RE: **#06ITB49977K-RS, Southwest Arts Center**

Addendum No.1

**SW Arts Phase II Performance Theatre**  
**ITB No. 06ITB 49977K-RS**  
**Addendum 1**  
**6/09/2006**

This Addendum forms a part of and modifies the bidding requirements and proposed Contract Documents for the subject Project, dated **May 8, 2006**. Receipt of this addendum shall be acknowledged on the Bid Form.

PROJECT NAME	PROJECT NO.	DATE	SHEET NO.
FULTON COUNTY SW ARTS PHASE II THEATER	01145	5-30-06	SK12
SHEET TITLE	REF. SHT.	REVISION	SCALE
DEVICE LOCATIONS: 1ST FLR. & MEZZANINE	AV 2.1 E2	Addendum 1	1/8" = 1'-0"

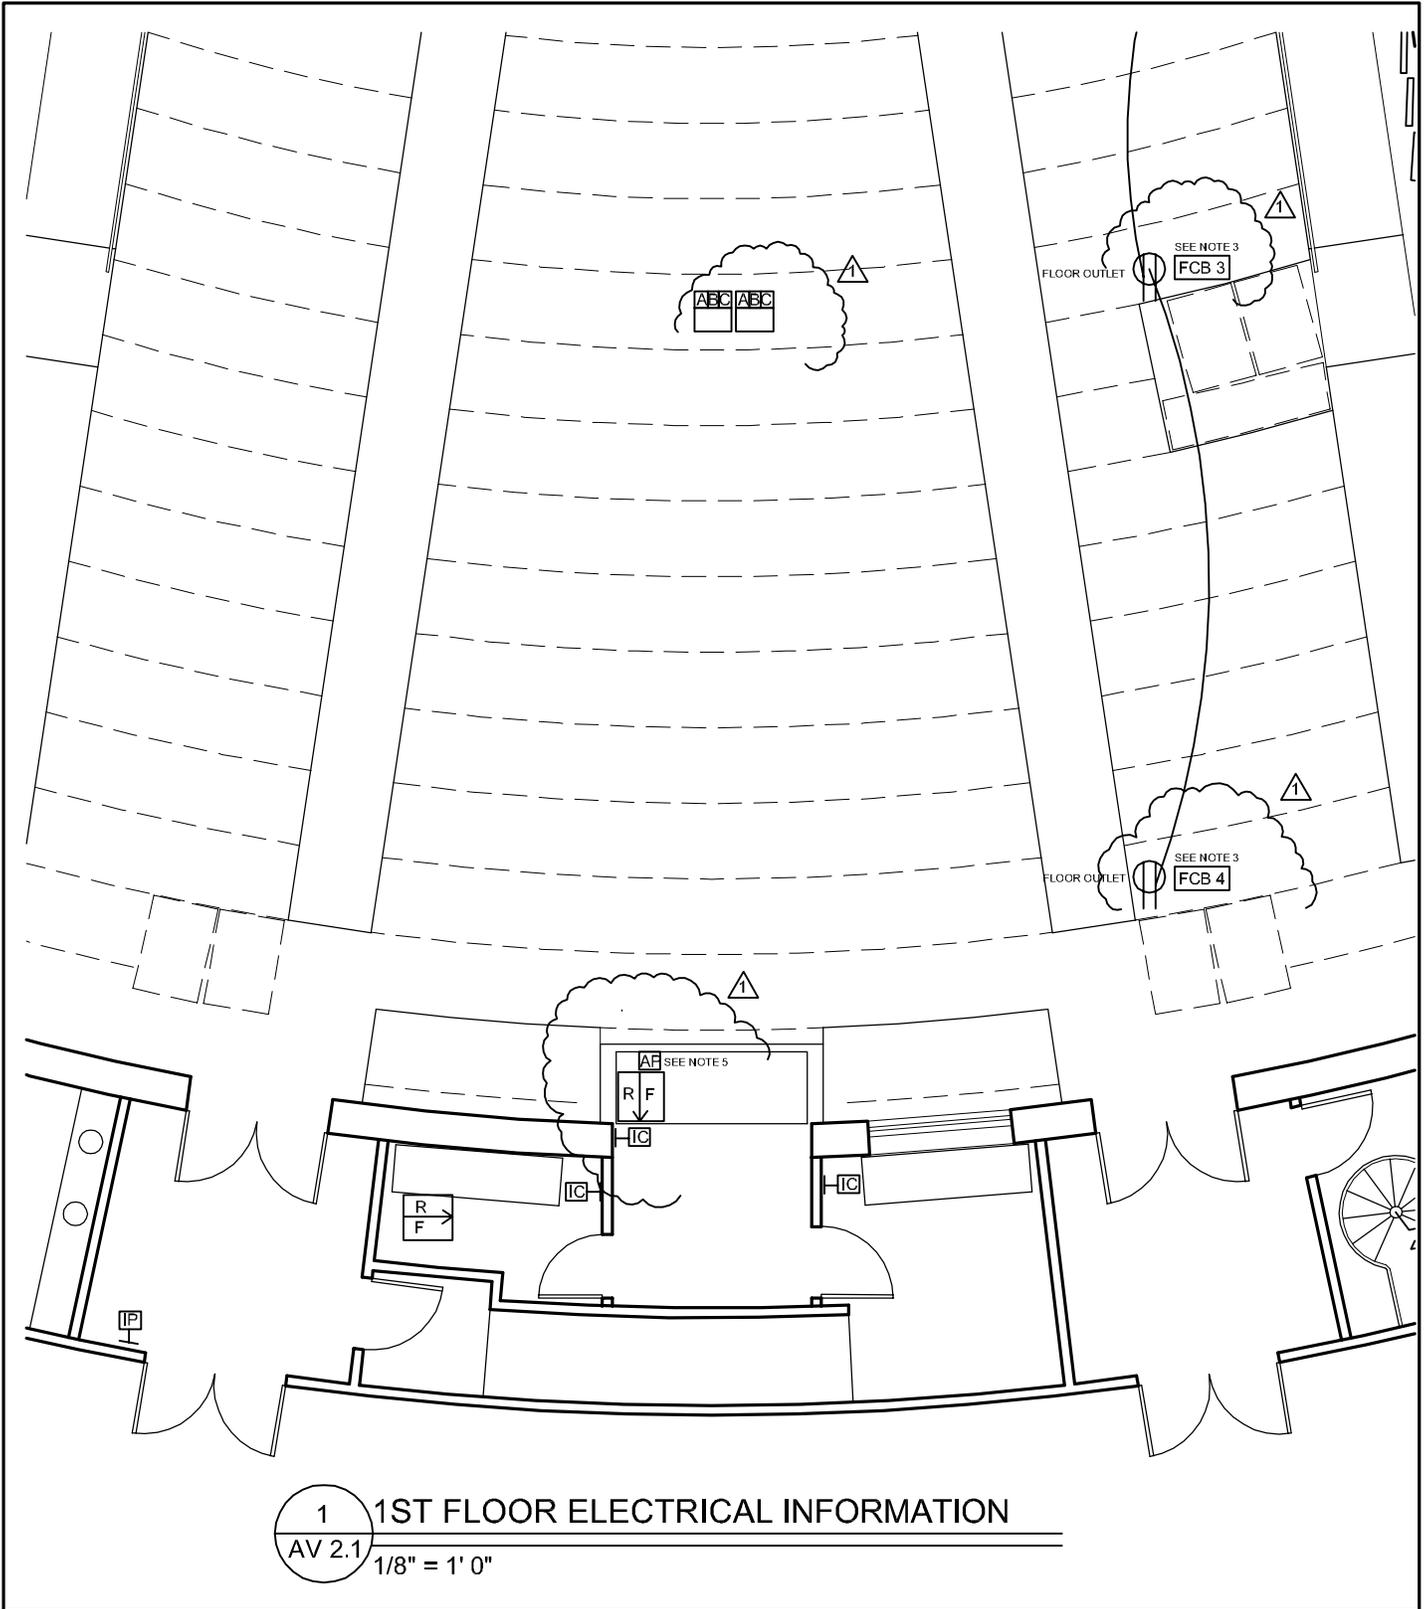
13. Issue SK-12:
  - Add power and box locations for camera locations in auditorium
14. Issue SK-13:
  - Add power and box locations for camera locations in auditorium

• PROJECT NAME	PROJECT NO.	DATE	SHEET NO.
• <i>FULTON COUNTY</i>	<i>01145</i>	<i>5-30-06</i>	<i>SK15</i>
• <i>SW ARTS</i>			
• <i>PHASE II THEATER</i>			
• SHEET TITLE	REF. SHT.	REVISION	SCALE
• <i>DEVICE LOCATIONS: 1ST</i>	<i>AV2.1</i>	<i>Addendum 1</i>	<i>NONE</i>
• <i>FLR. &amp; MEZZANINE</i>

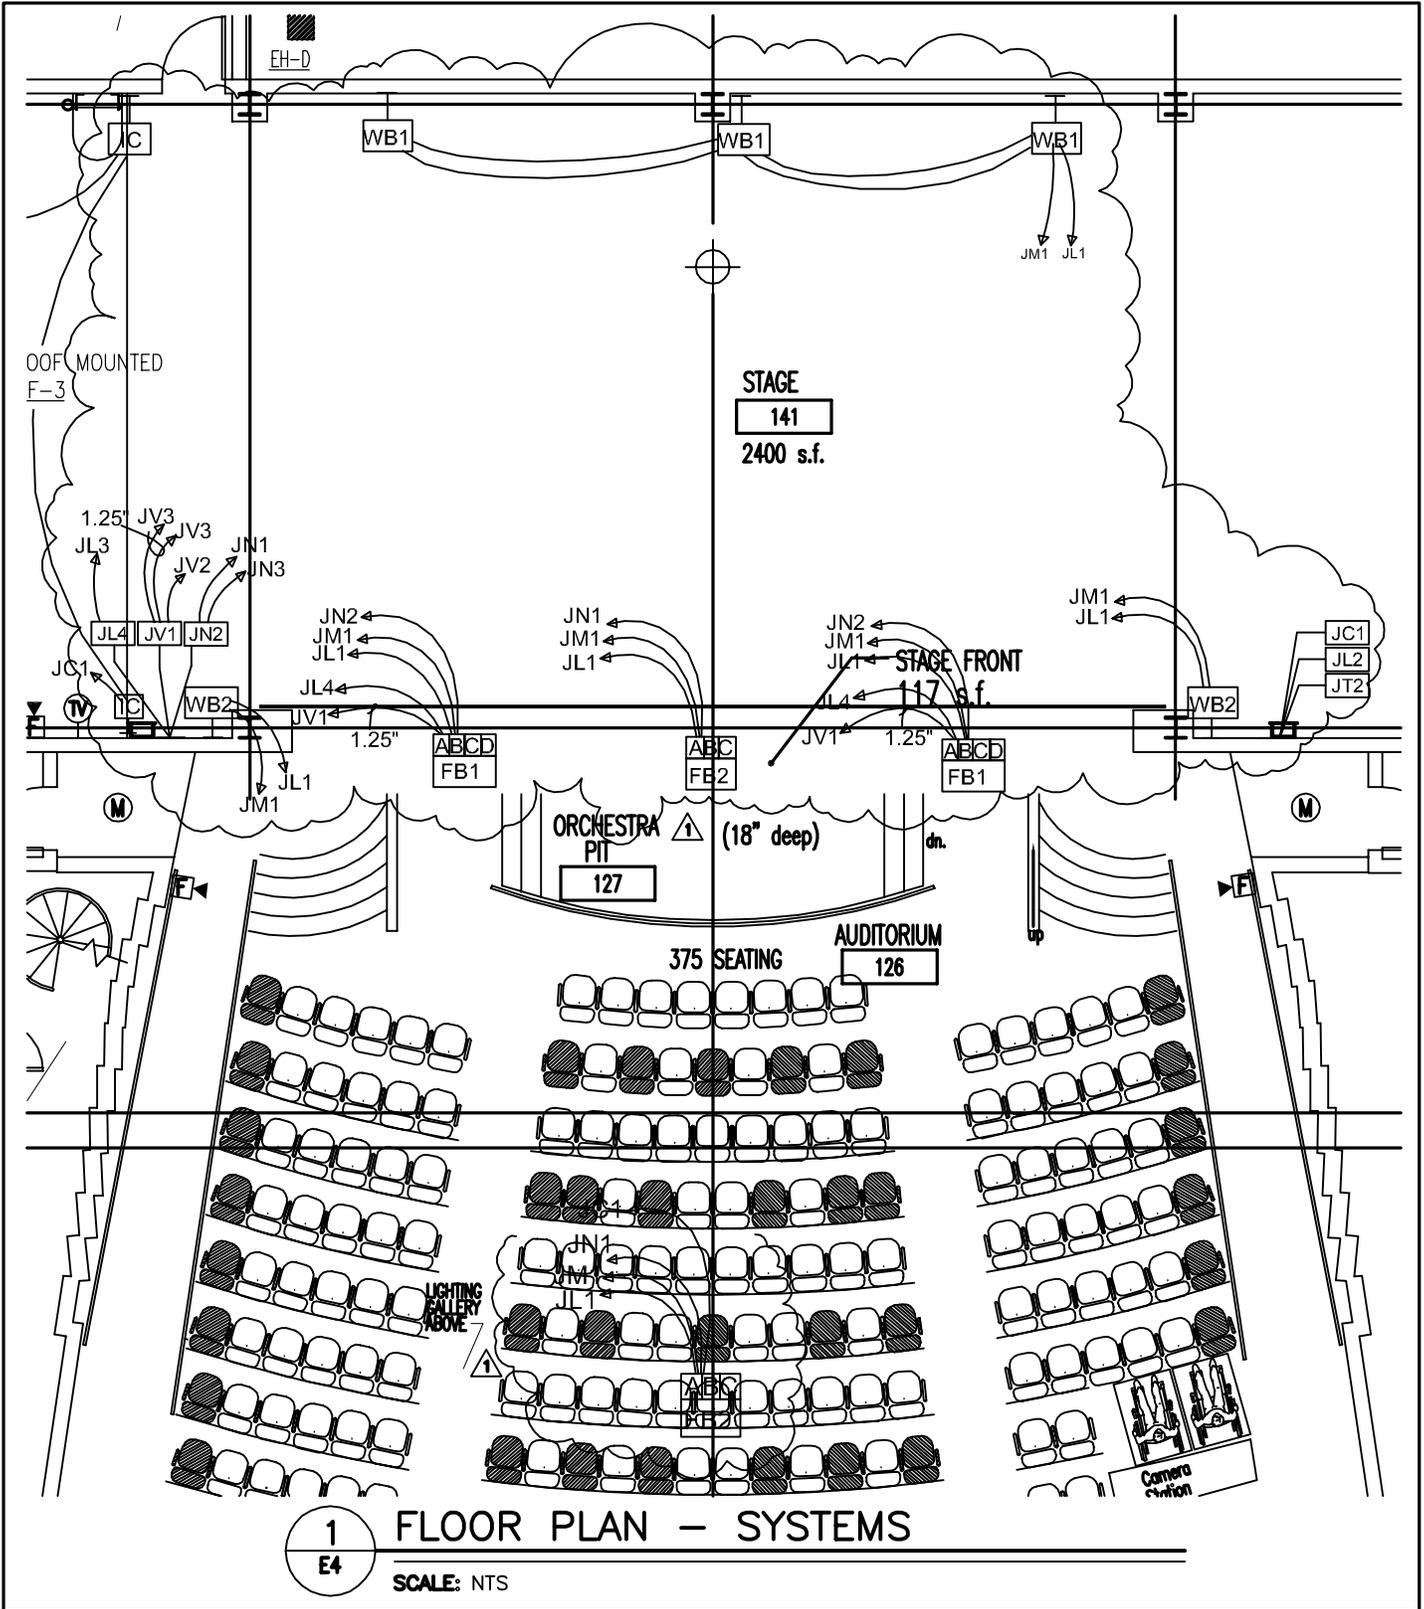
15. Issue SK-14:
  - Add power and patch panel locations in scene shop
16. Issue SK-15:
  - Add notes for camera locations, cabling and patchbays
17. Issue SK-16:

- PROJECT NAME
- **FULTON COUNTY**
- **SW ARTS**
- **PHASE II THEATER**
- SHEET TITLE
- **FLOOR PLAN -**
- **SYSTEMS**

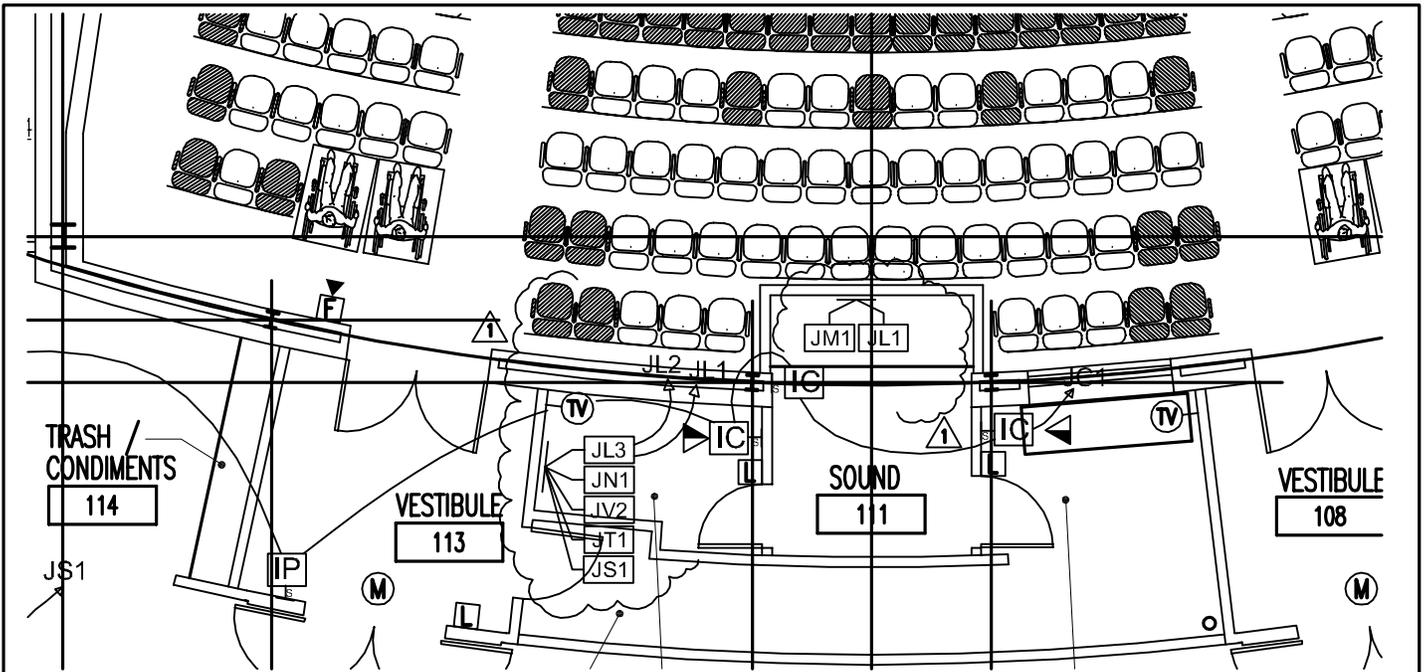
- Clarify stage box types
18. Issue SK-17:
  - Indicate conduit locations and cabling terminations for auditorium AV boxes
19. Issue SK-18:
  - Delete note referencing UVC Emitter at HVAC AHU

PROJECT NAME	PROJECT NO.	DATE	SHEET NO.
FULTON COUNTY	01145	5-30-06	SK20
SW ARTS			
PHASE II THEATER			
SHEET TITLE	REF. SHT.	REVISION	SCALE
FOUNDATION AND FLOOR	S1.1	Addendum 1	NTS
SLAB PLAN

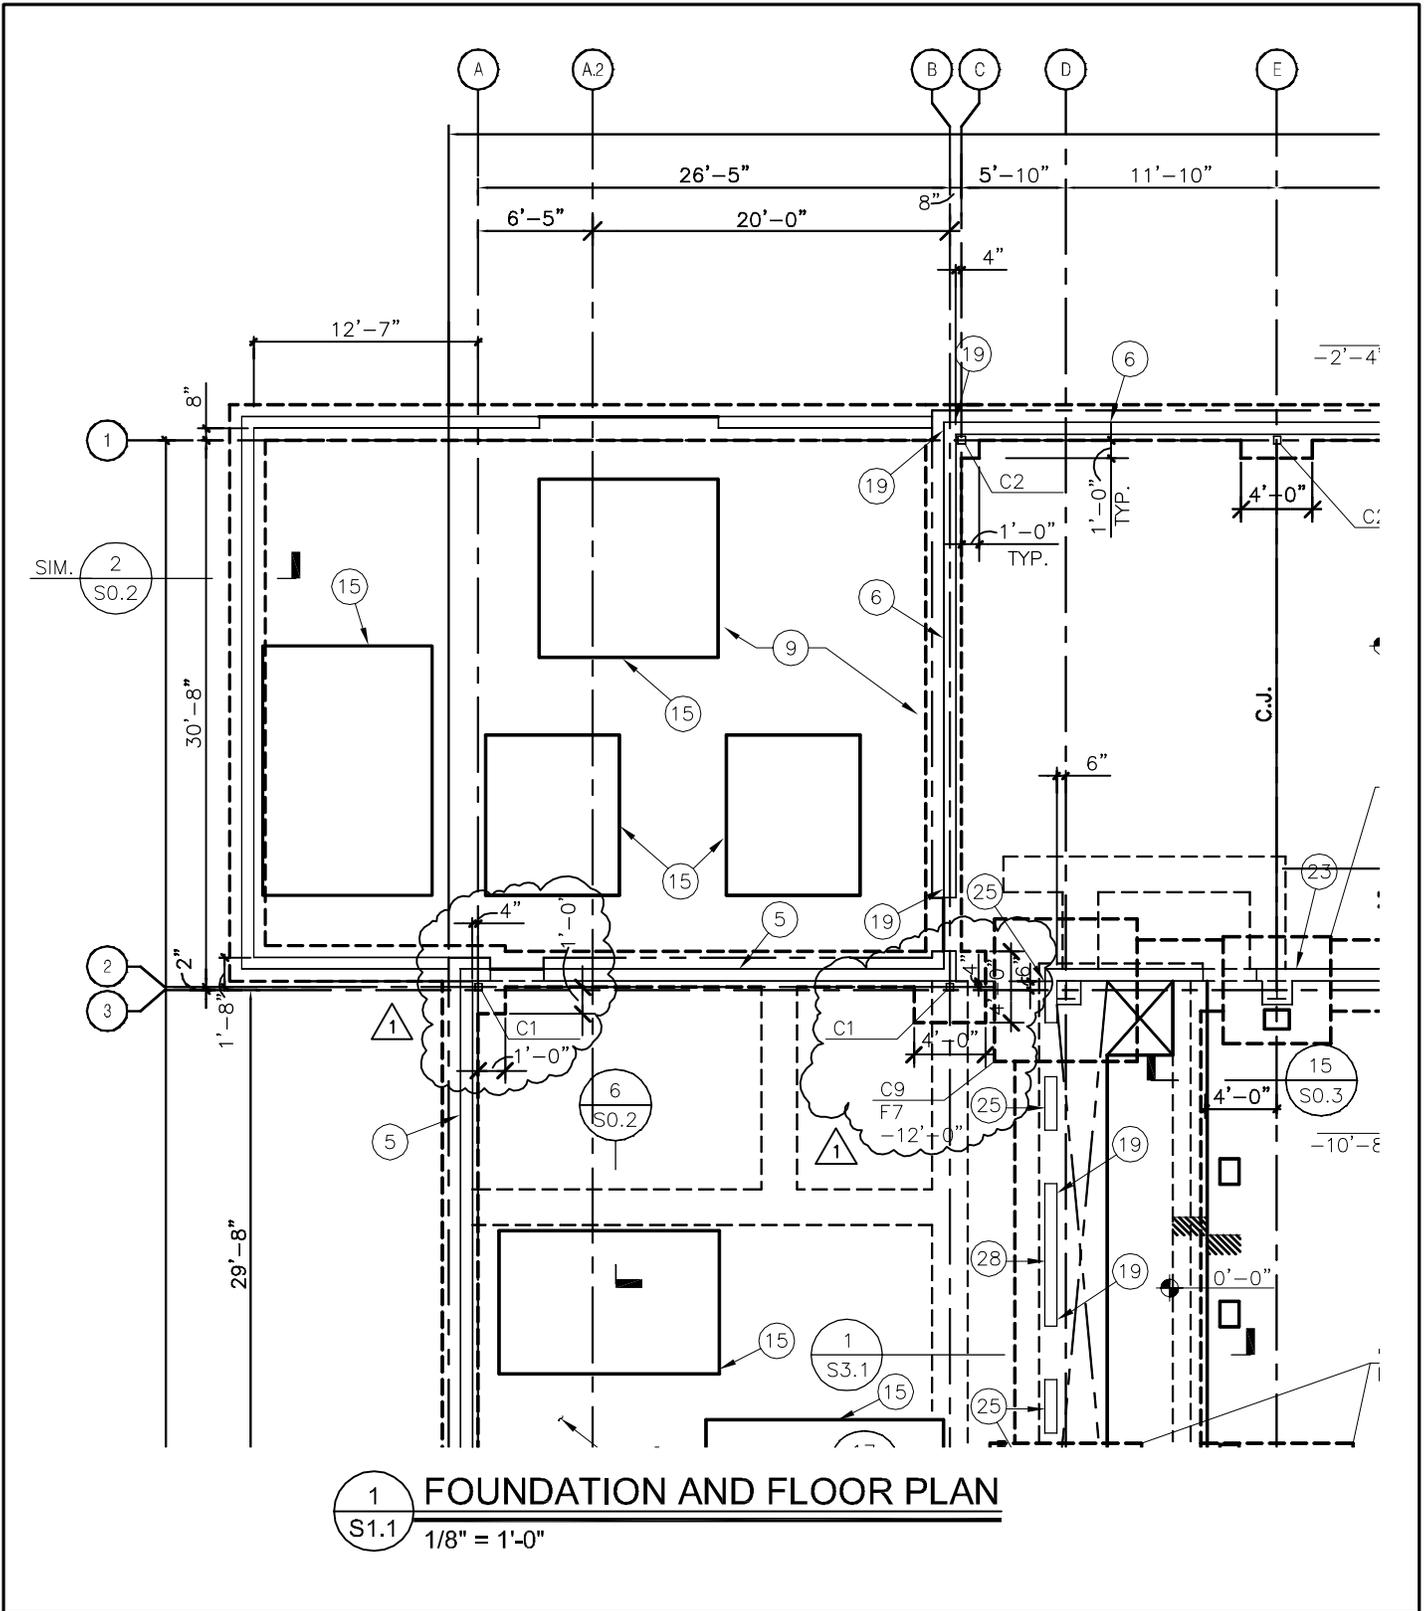
20. Issue SK-19:
  - Add Carel as acceptable steam humidifier manufacturer
21. Issue SK-20:
  - Revise note to coordinate structural with architectural detail of slab subgrade

11 CAMERA FLOOR BOX  
 AV 4.1 NTS

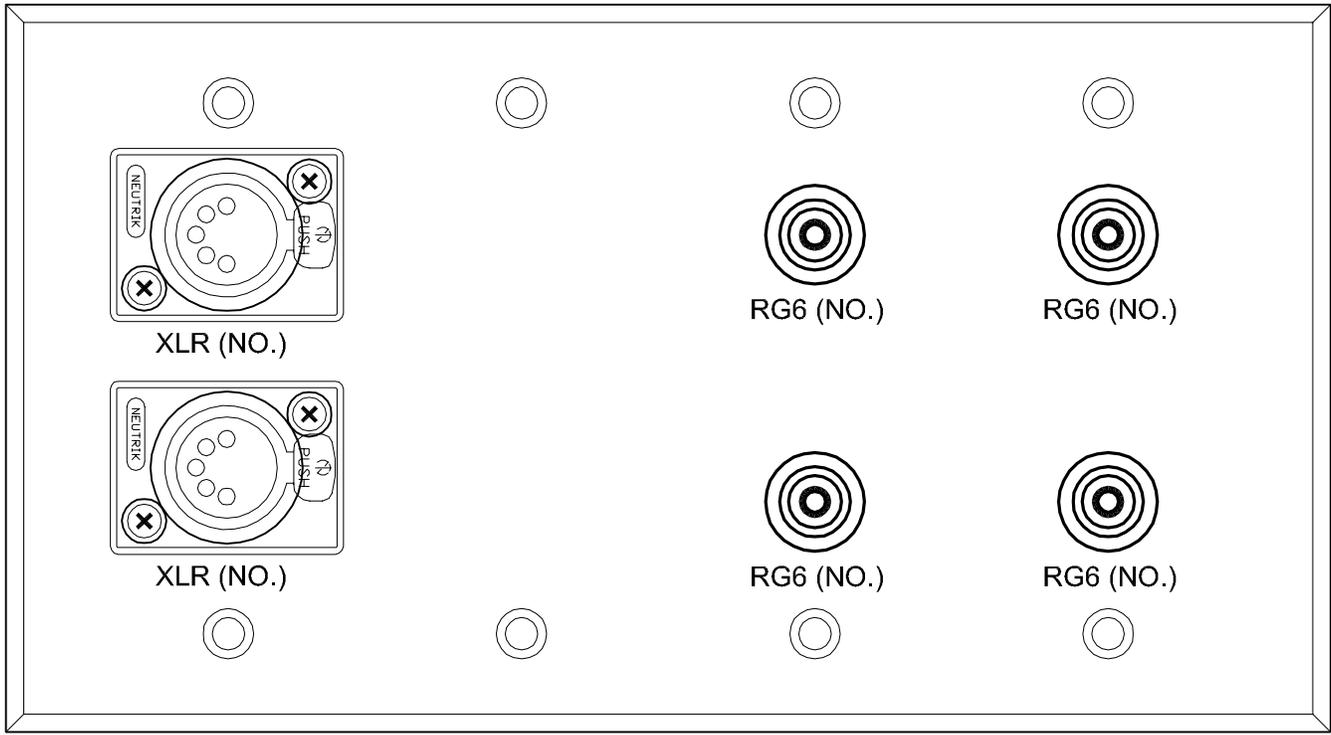
25. Issue SK-24:
  - Add note 30 for construction of mezzanine at scene shop above office space
26. Issue SK-25:
  - Add camera floor box plate details
27. Issue SK-26:

12 CAMERA FLOOR BOX  
 AV 4.1 FULL SIZE

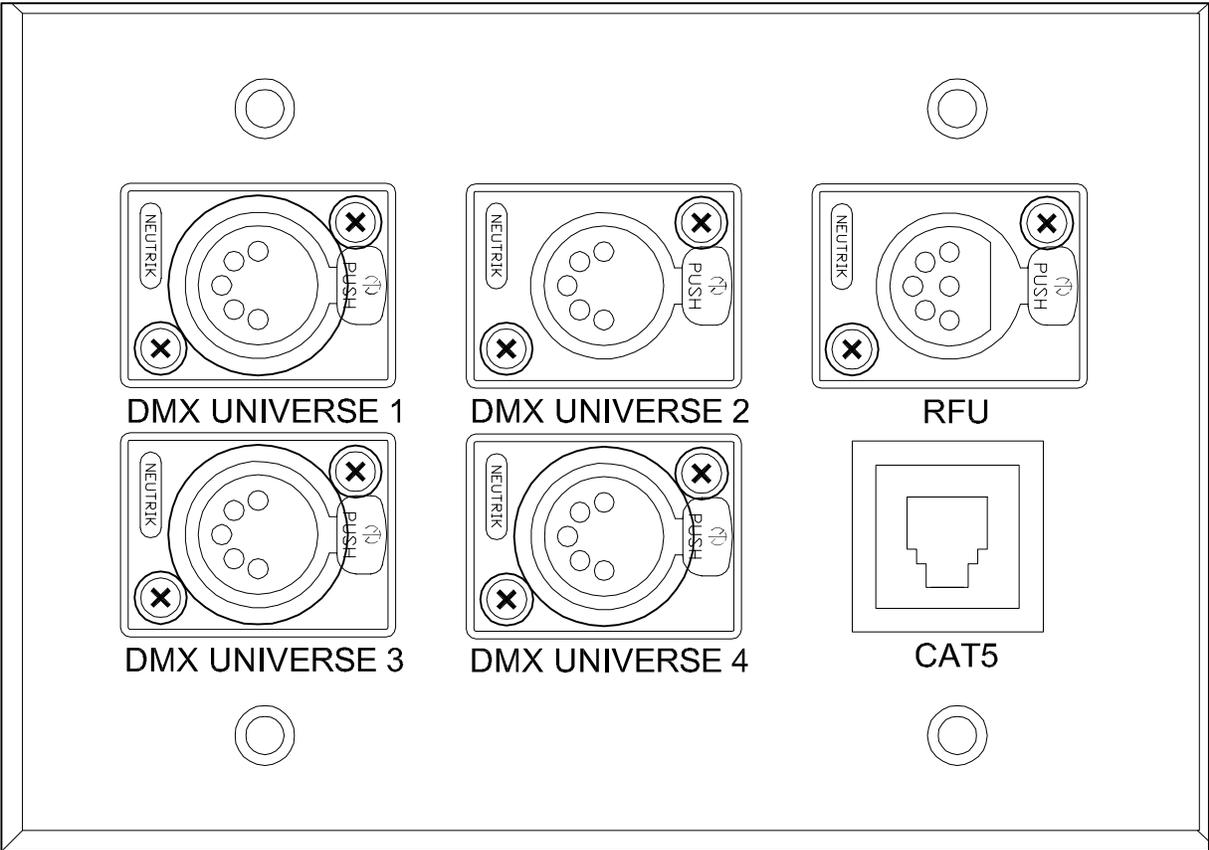
- Add camera floor box plate details
28. Issue SK-27:
  - Clarify floor finish at door 009
  - Add finishes for Closet 152
